PROJECT: Thornton Street Improvements, Maureen to Vista

ADDENDUM 1

THORNTON STREET IMPROVEMENT PROJECT, MAUREEN TO VISTA
Federal Aid No. STPUS-8044(002)

ADDENDUM NO. 1
To the Contract Provisions for
CITY OF FERNDALE, WASHINGTON

JOB# / DWG	DATE
11037 SP4	4-15-13
SCALE: H:1"=20' V:1"=2'	SHEET
	10 of 21

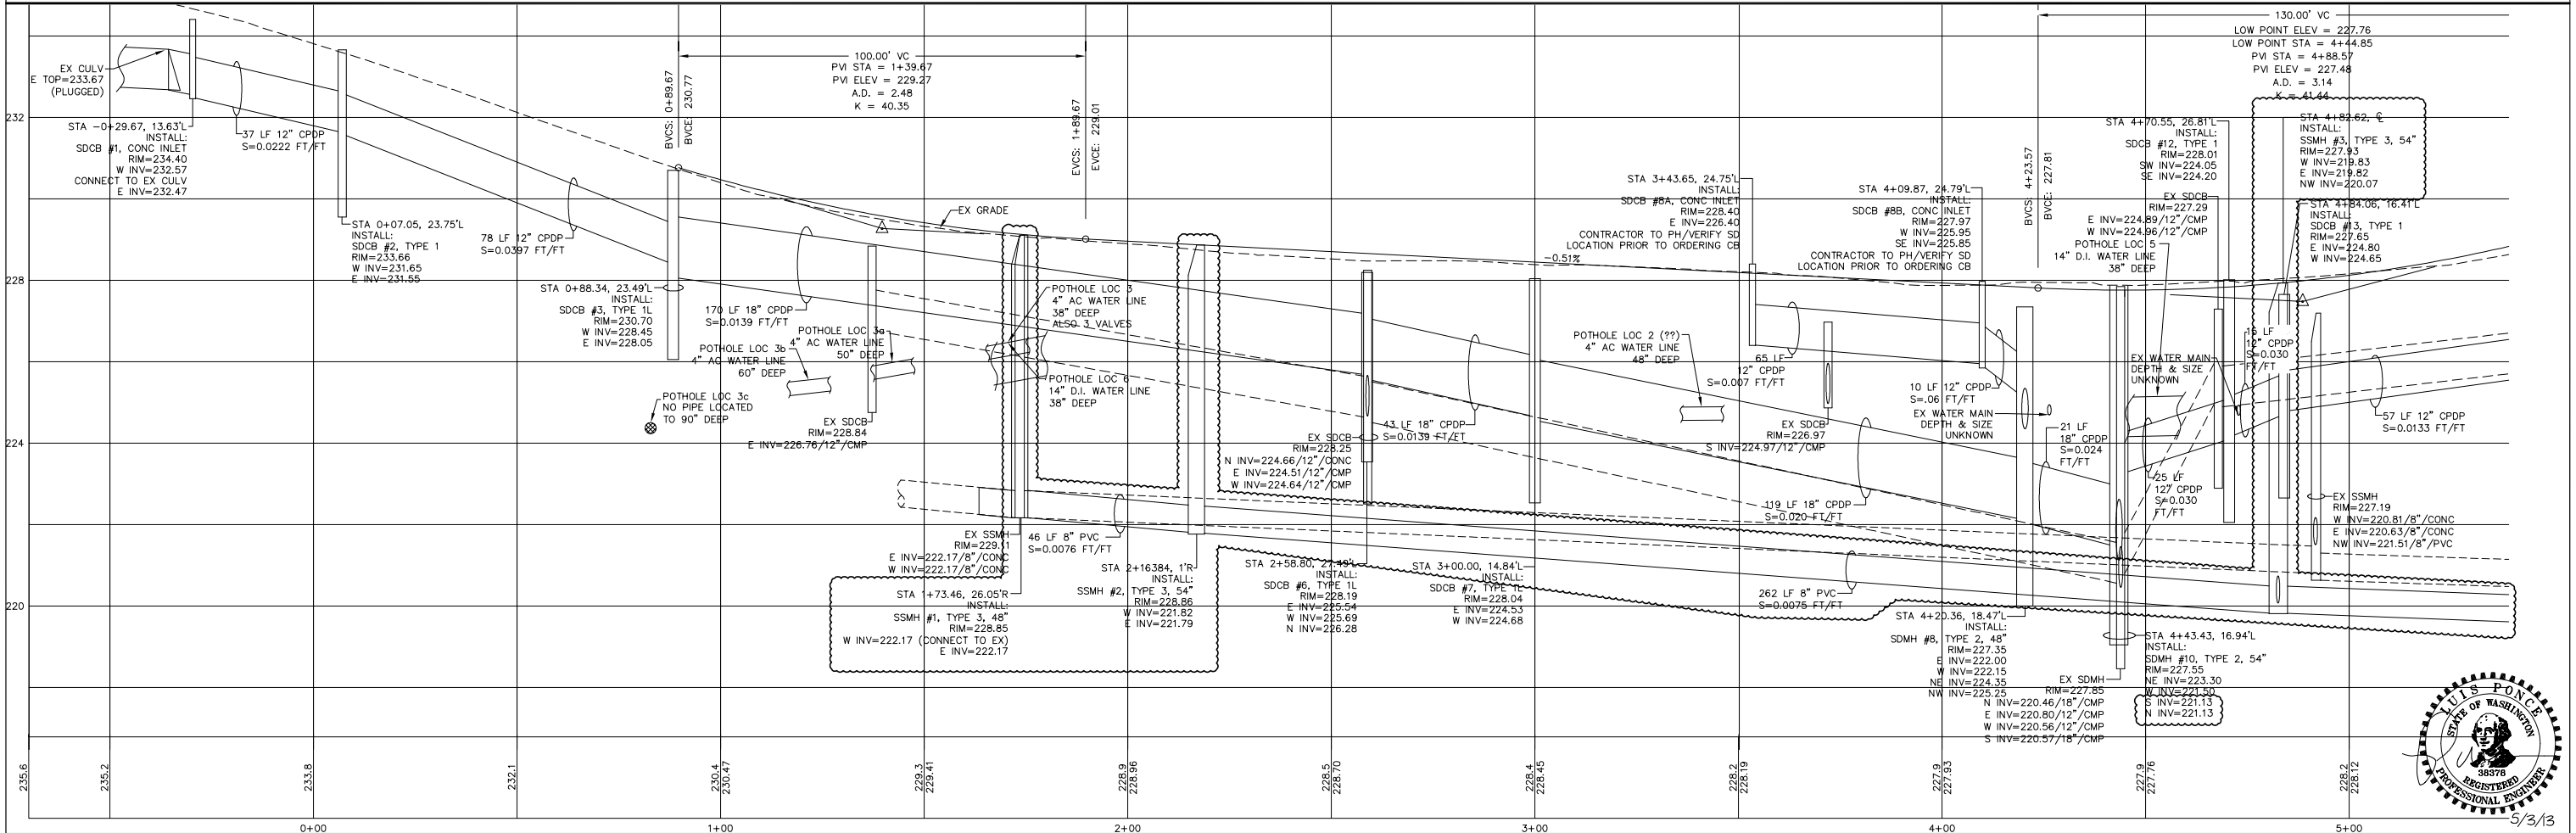
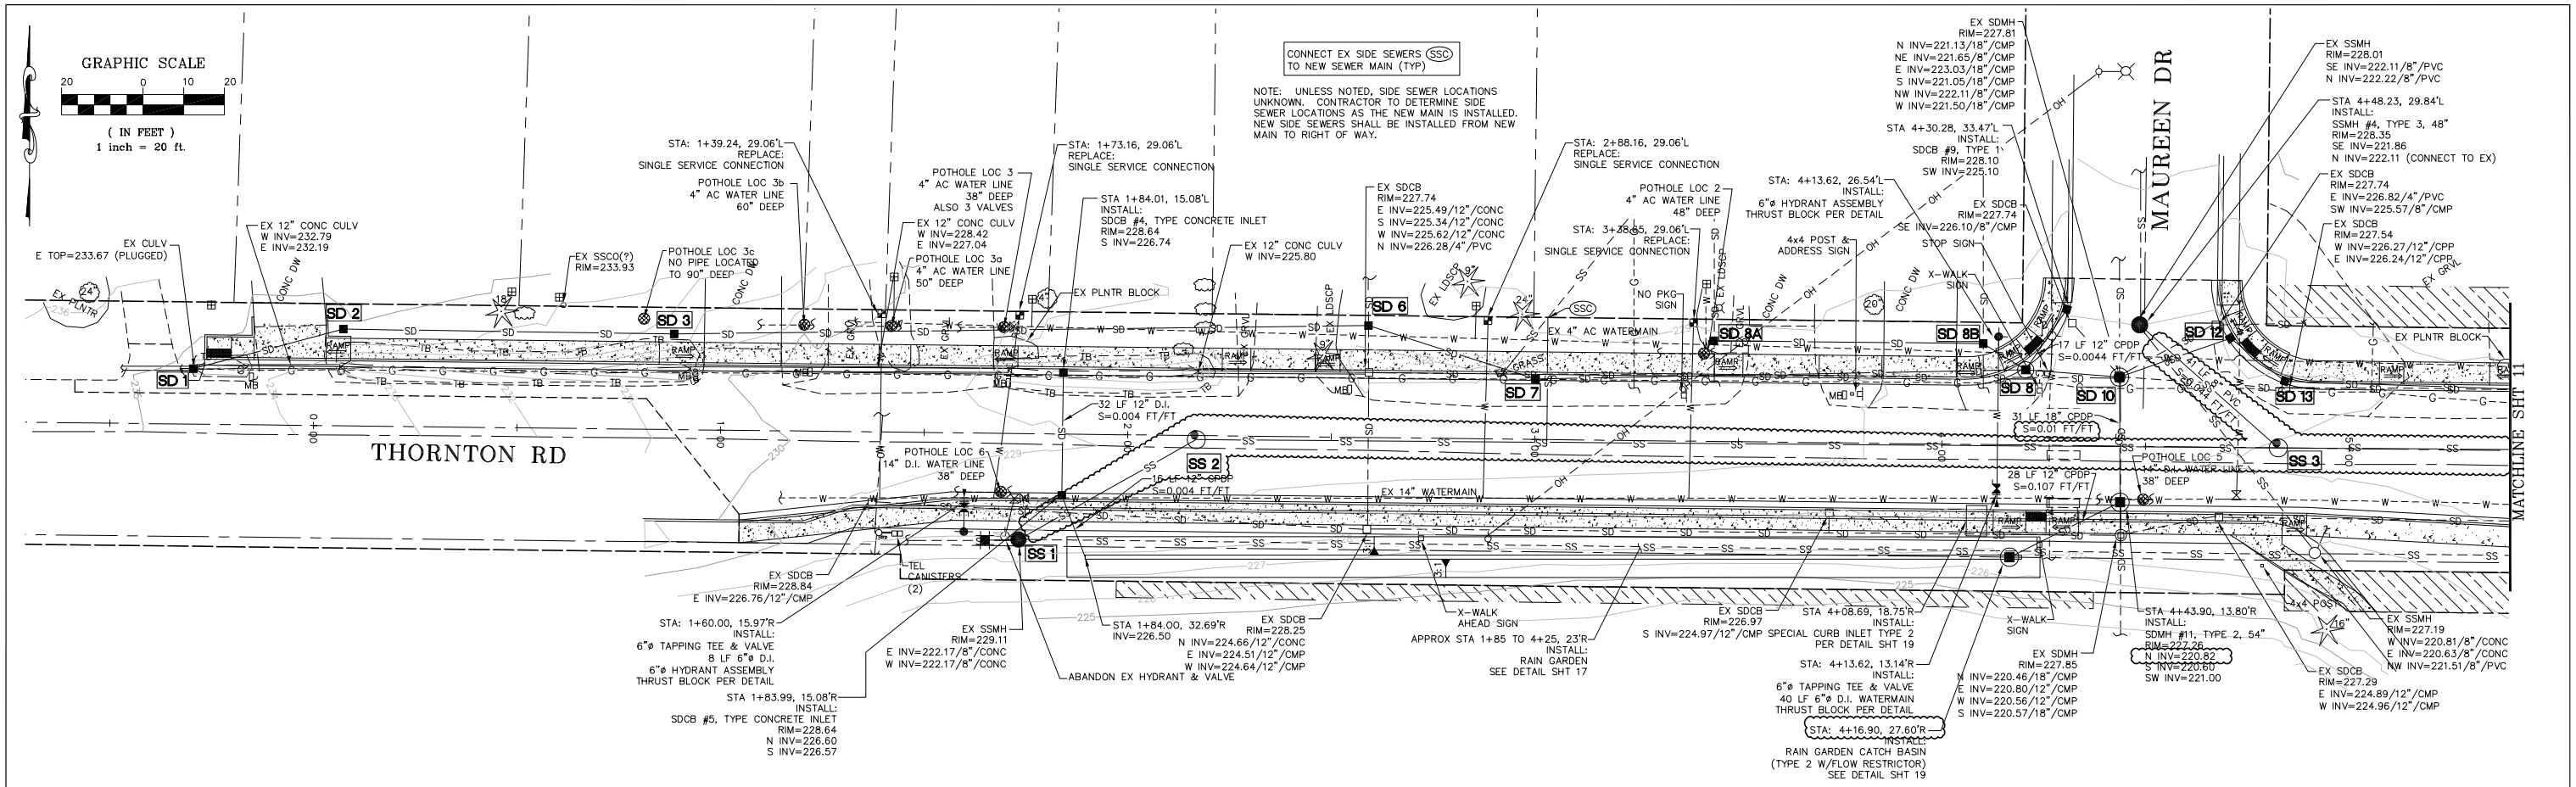
Plan Sheets 10, 11, 12

The attached Plan Sheets 10, 11, 12, shall replace the Plan Sheets 10, 11, 12, dated 4/15/13.
The sanitary sewer is relocated and the storm drain run between SD 10 to SD 11 is revised.

Plan Sheets 10, 11, 12

The note that reads:

'NOTE: UNLESS NOTED, SIDE SEWER LOCATIONS UNKNOWN. CONTRACTOR TO DETERMINE SIDE SEWER LOCATIONS AS THE NEW MAIN IS INSTALLED. FOR BASE BID, NEW SIDE SEWERS SHALL BE INSTALLED FROM NEW MAIN TO RIGHT OF WAY.'

Is revised to read:

Plan Sheets 10

The SSCO located at STA 1+53.46, 26.52 R is deleted.
The 'RAIN GARDEN CATCH BASIN' offset has been adjusted.

'NOTE: UNLESS NOTED, SIDE SEWER LOCATIONS UNKNOWN. CONTRACTOR TO DETERMINE SIDE SEWER LOCATIONS AS THE NEW MAIN IS INSTALLED. NEW SIDE SEWERS SHALL BE INSTALLED FROM NEW MAIN TO RIGHT OF WAY.'

JOB# / DWG	DATE
11037 SP4	4-15-13
SCALE	SHEET
H: 1" = 20' V: 1" = 2'	11 of 21

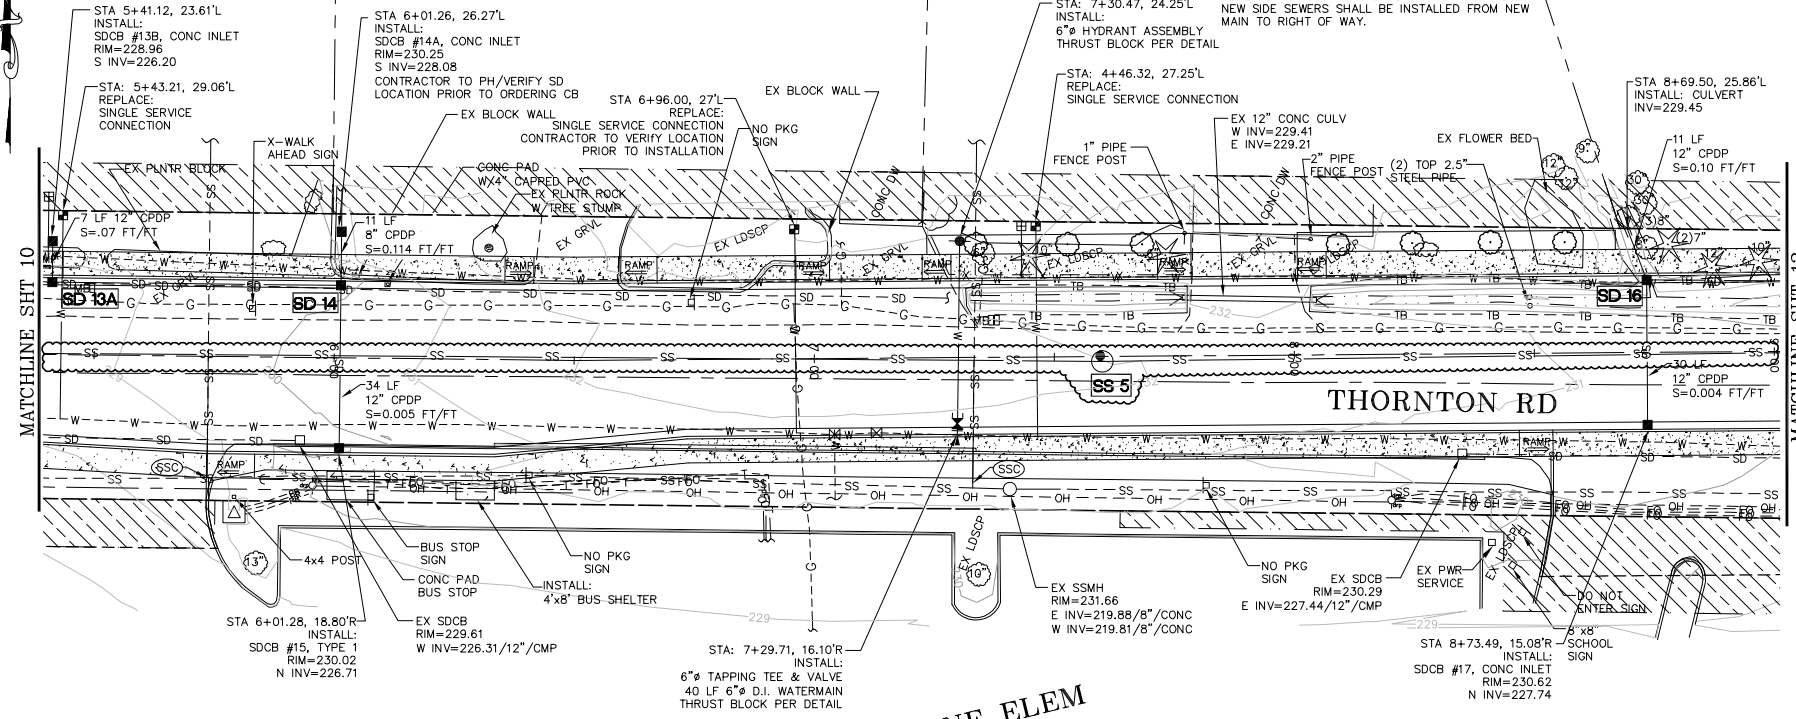
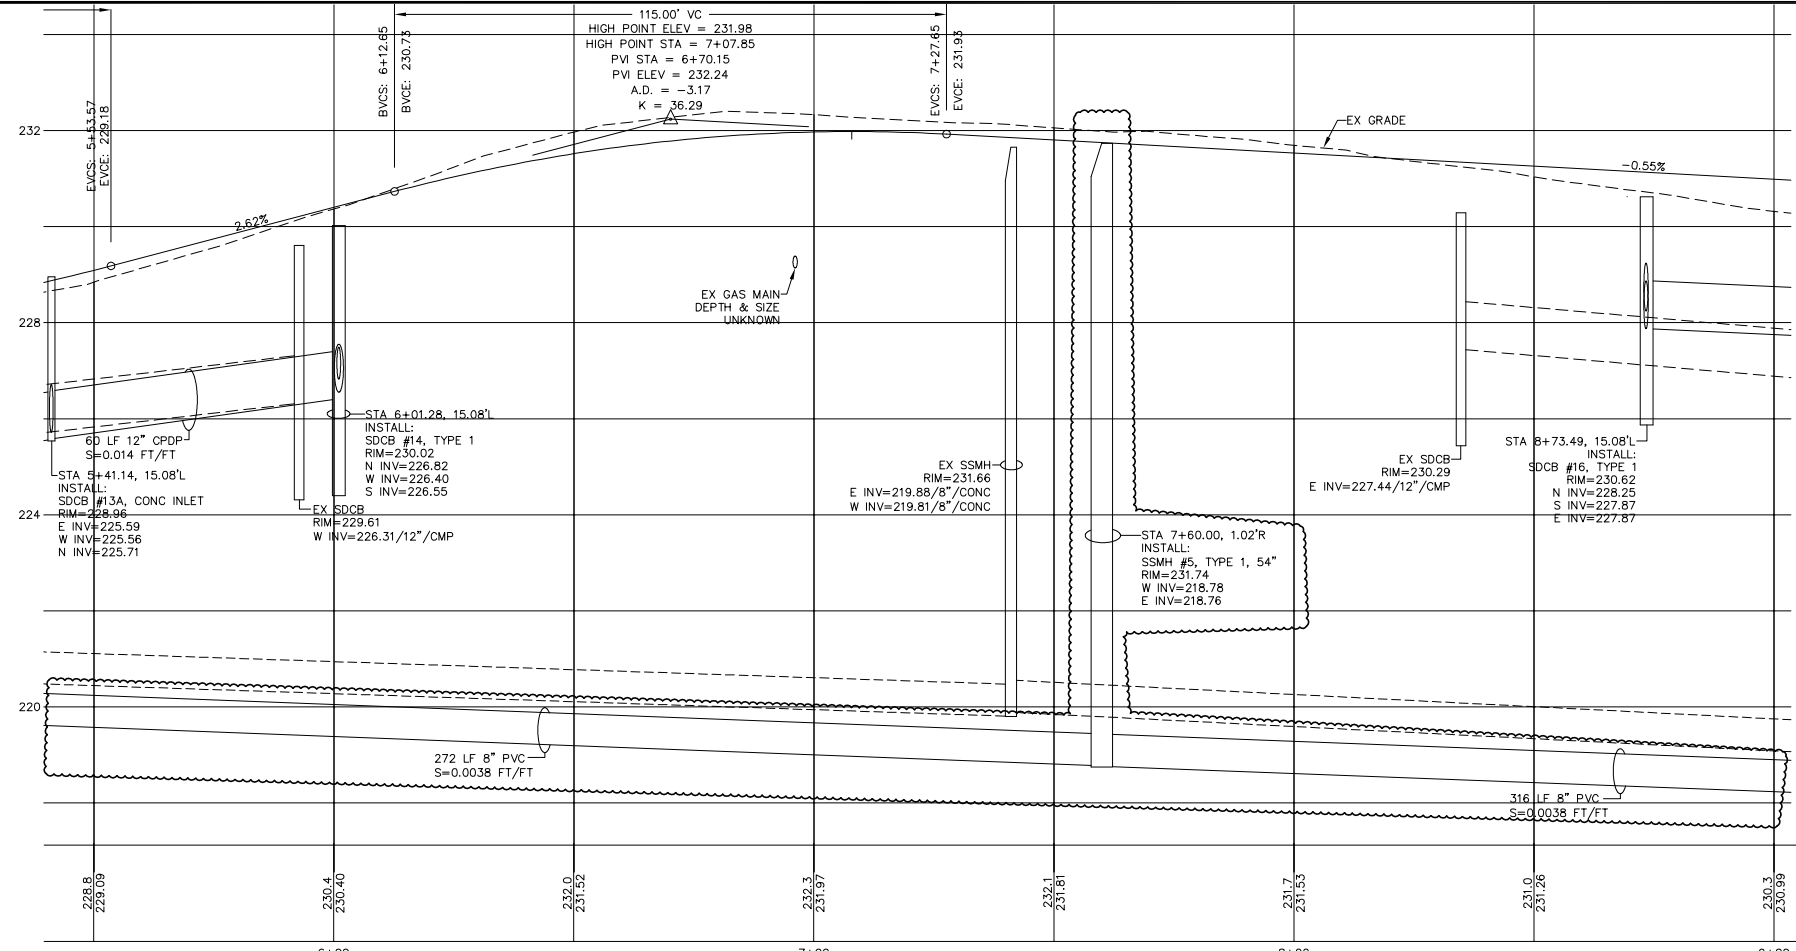
Plan Sheet 11

The single service connection located at approximately 6+63 L, shall be located at approximately 6+96, 27' L.

RAIN GARDEN PLANTING ENLARGEMENT

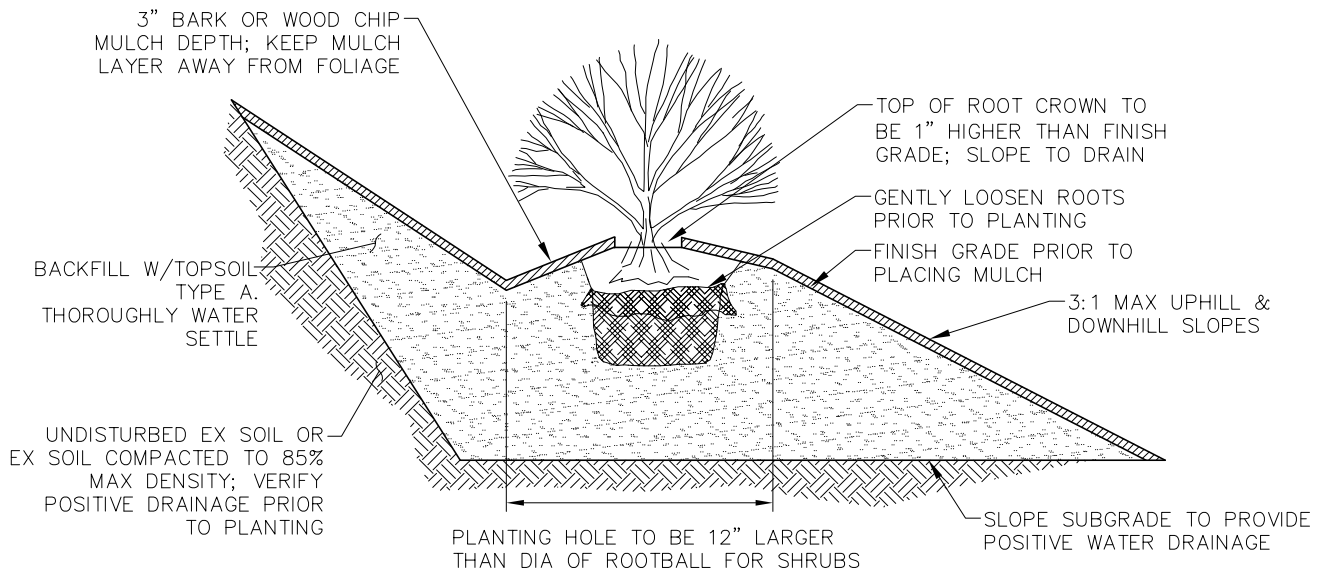
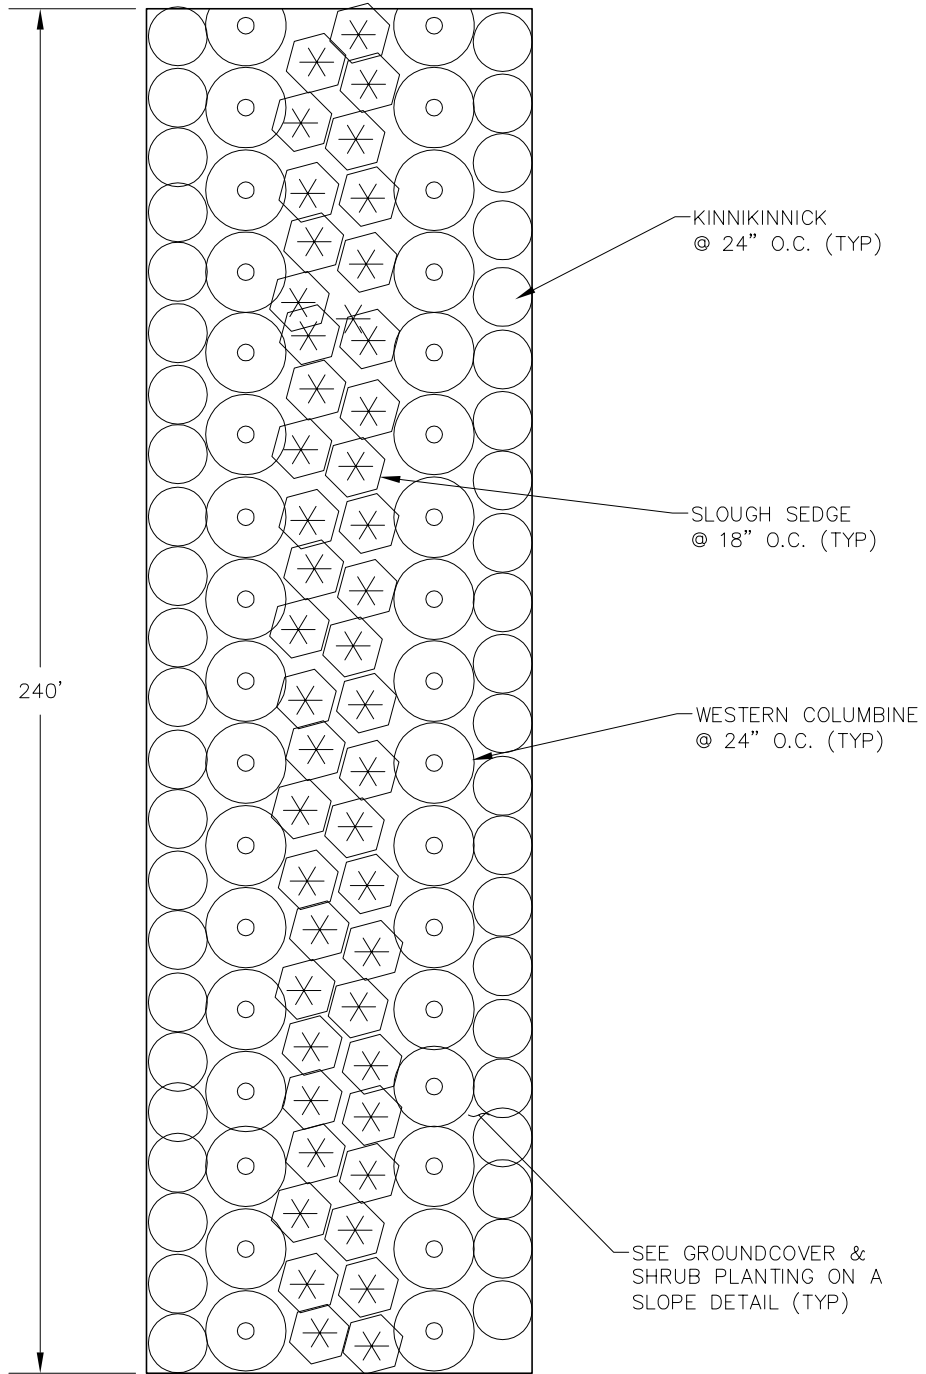
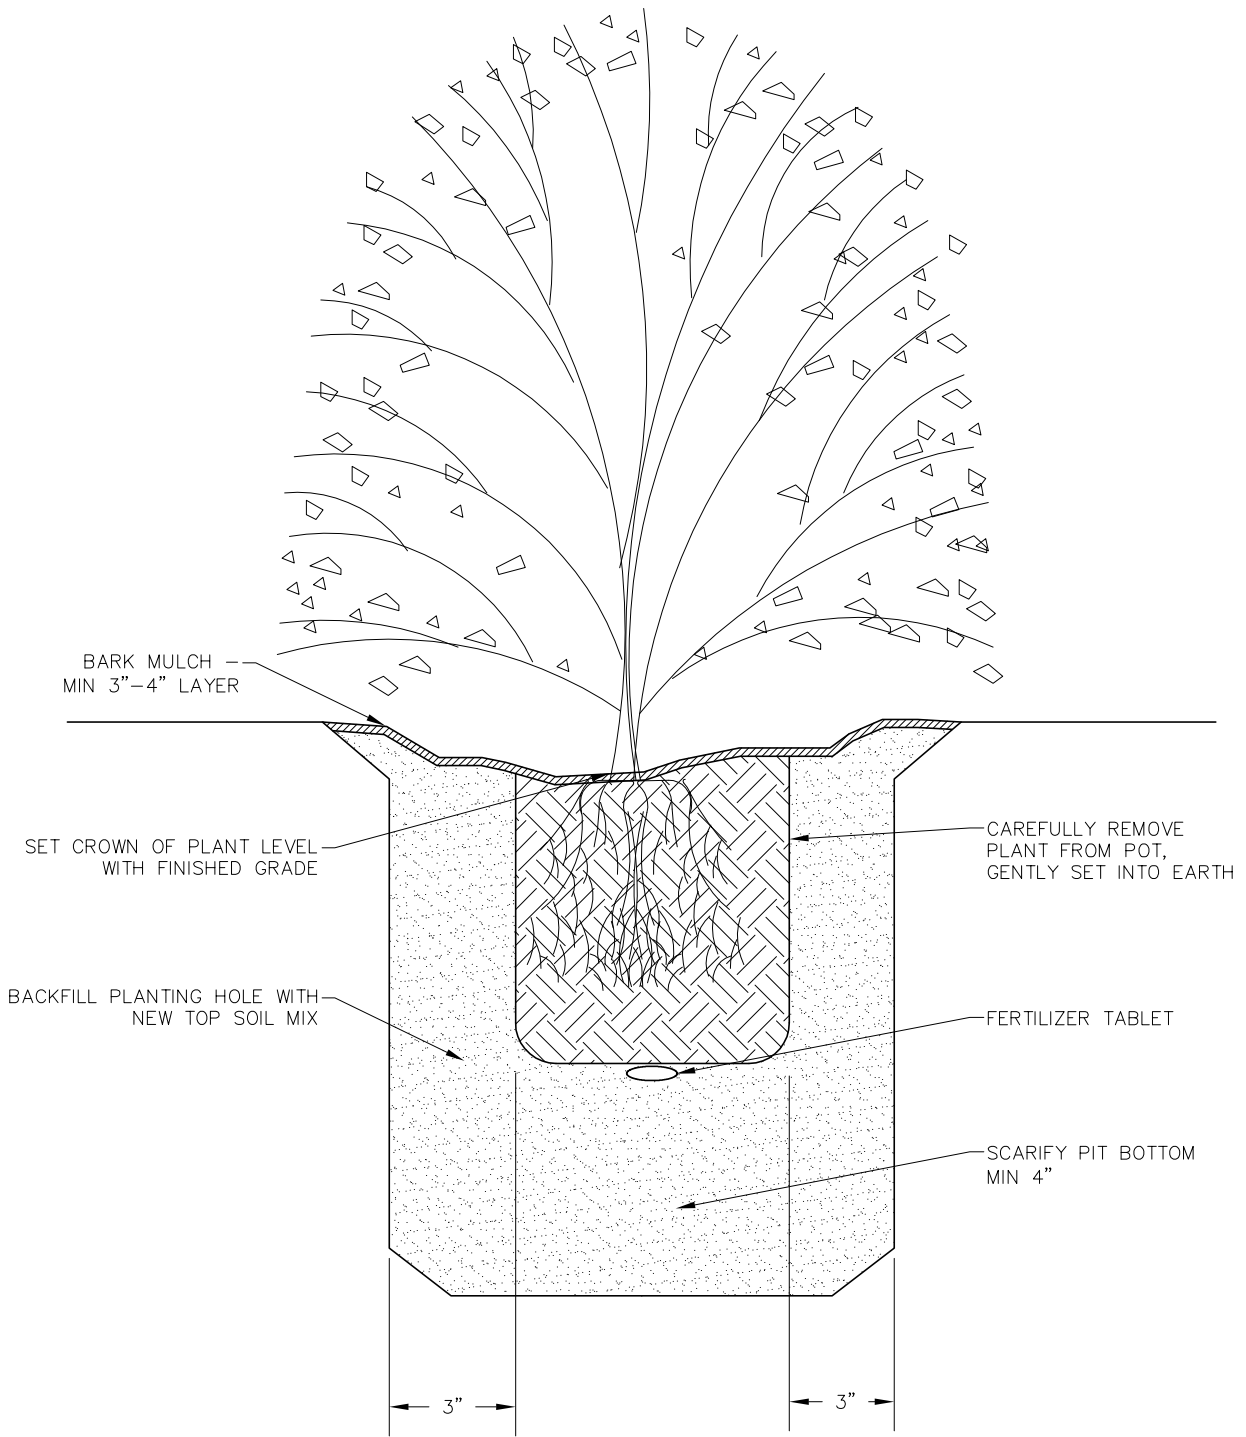
The attached Rain Garden Planting Details and Plant List are added to the Contract Documents.
